File
12D-91
6 May 1957

Field Expedient for Crystal Marine Sys

TEMP MOD FOR CRT HI-VOLT "INPUT VOLT."

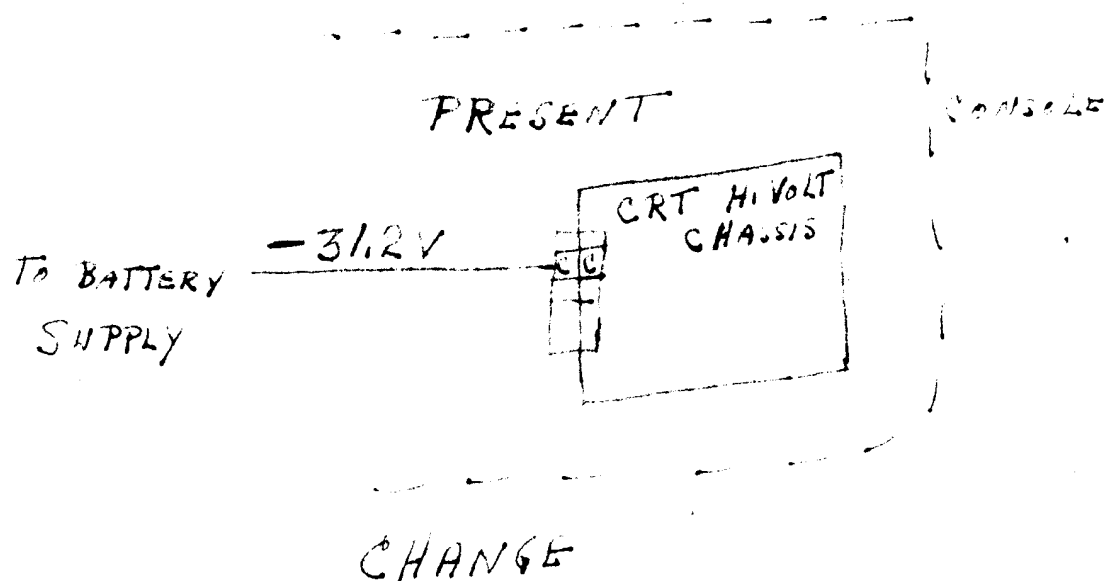
[redacted] Washington, covering their recommended connection of the additional 5-V battery to improve the performance of the CRT high voltage supply.

2. This is considered a field expedient pending the re-design of the Hi-voltage power supply by the [redacted]

1. REMOVE PRESENT $-31.2V$ WIRE FROM PIN "C" OF PLUG, GOING TO CRT HI-VOLT CHASSIS
2. INSERT 5-VOLT PACK IN SERIES WITH EXISTING $-31.2V$ LEAD REMOVED FROM PIN "C" AND CONNECT NEW LEAD TO PIN "C".
